NAVISTAR, INC

DEFECT INFORMATION REPORT

REPORT ID: 15-I6-12000801-01
Revision.: -
Ref. Investigation.: -
Ref. AFC:-
Ref. VER:- 15515

This report addresses a calibration defect regarding the Electronic Control Module (ECM).

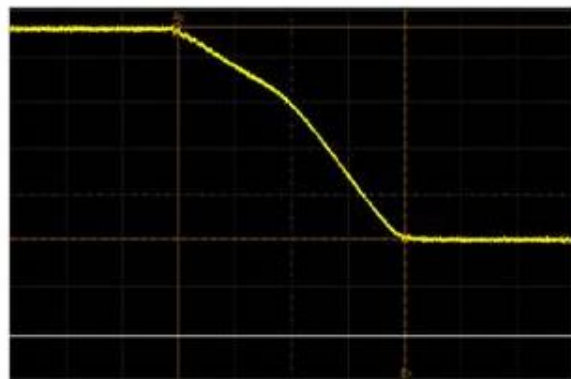
Navistar certified N9 and N10 engines with SCR aftertreatment for the 2014 model year. To help reduce CPU loading of the ECM the clock frequency was increased from 56 MHz to 64MHz. When the clock frequency was increased the clock signal slew rate was also increased (mistakenly). The increased slew rate caused “ringing” of the clock signal which in turn caused read errors to occur in the ECM and ultimately memory corruption (reference left photo below). When the clock slew rate was slowed to the original rate the ringing was completely eliminated (reference right photo below) along with the read errors and occurrences of memory corruption.

Current situation: Without Slew Rate Control or fast slew rate (Frequency 1 MHz)

Solution: With Slew Rate Control or slow slew rate (Frequency 1 MHz)

Navistar intends to perform a voluntary emissions recall (#15515), consisting of a new ECM calibration. This calibration will return the clock slew rate to the pre- 2014 MY value.
